Economic Commission for Europe**Inland Transport Committee****World Forum for Harmonization of Vehicle Regulations****153rd session**

**1958 Agreement – Consideration of draft amendments
to existing Regulations submitted by GRE****Proposal for the 04 series of amendments to
Regulation No. 10 (Electromagnetic compatibility)****Submitted by the Working Party on Lighting and Light-Signalling
(GRE)***

Model B

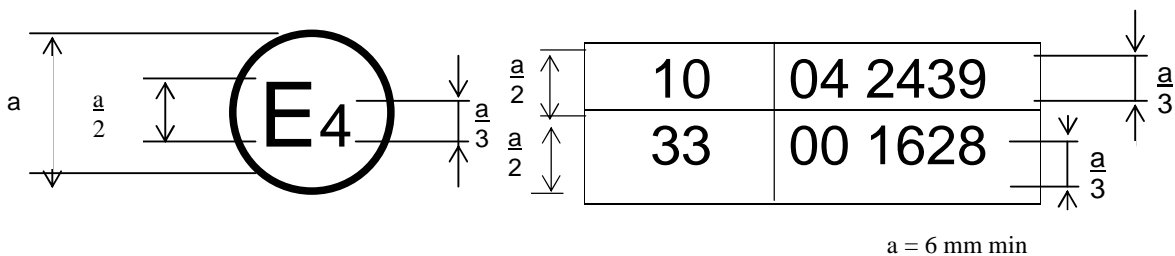
Annex 1, amend to read:

The above approval mark affixed to a vehicle or ESA shows that the vehicle type concerned has, with regard to electromagnetic compatibility, been approved in the Netherlands (E 4) pursuant to Regulations Nos. 10 and 33. *

The approval numbers indicate that, at the date when the respective approvals were given, Regulation No. 10 included the 04 series of amendments and Regulation No. 33 was still in its original form."

"Figure 3

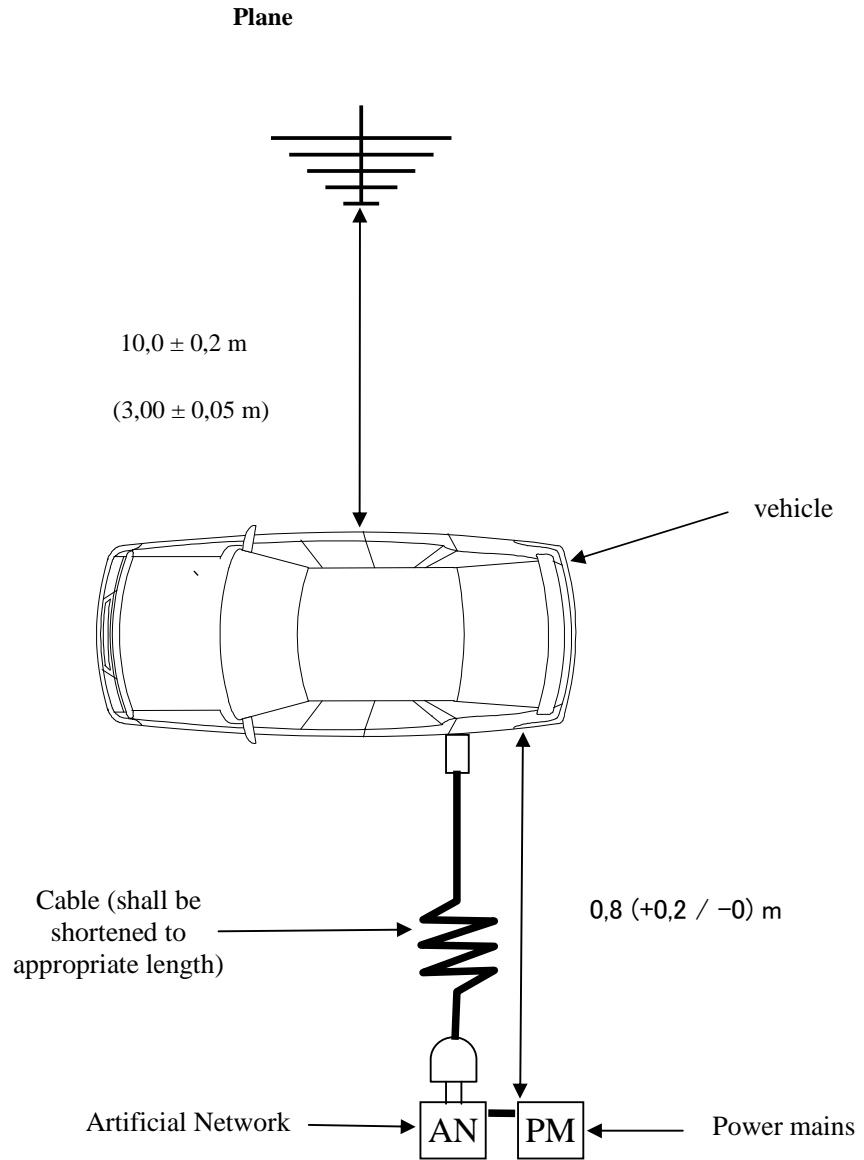
Insert a new figure 3, to read:

Vehicle in configuration "RESS charging mode" coupled to the power grid Elevation"

This vehicle shall be in battery charging mode at rated power until the AC or DC current reached at least 80 per cent of its initial value. The test set-up for the connection of the vehicle in configuration "RESS in charging mode coupled to the power grid" is shown in figure 3 of Appendix 1 to this annex."

"Figure 4

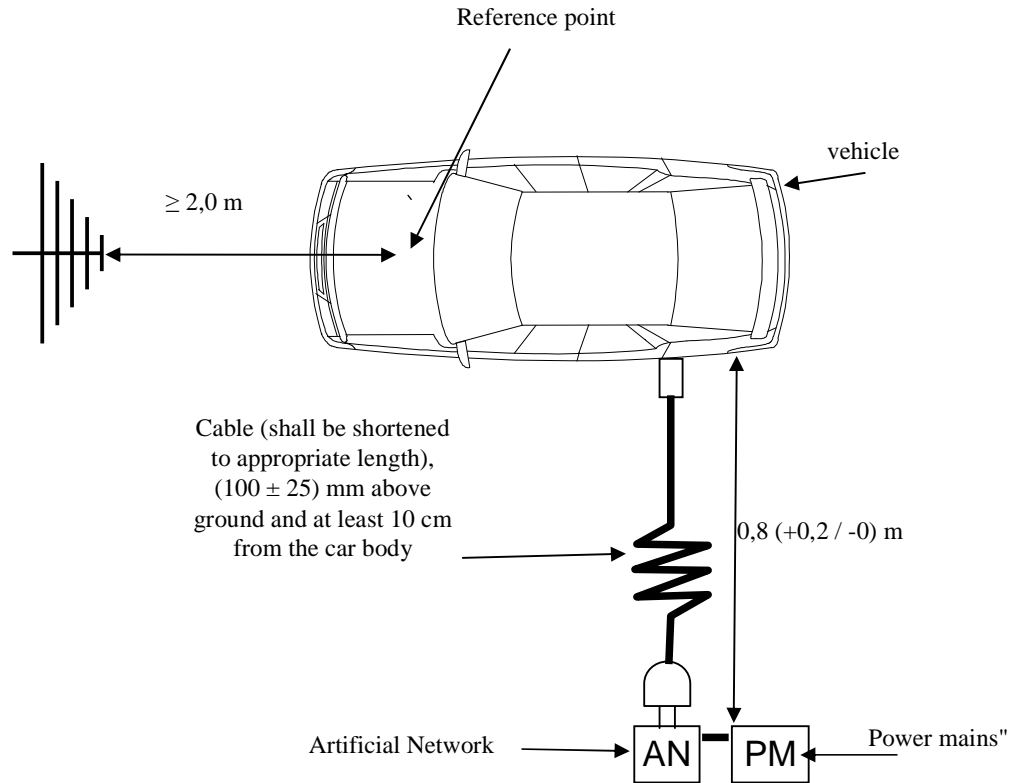
Insert a new figure 4, to read:

Vehicle in configuration "RESS in charging mode coupled to the power grid"
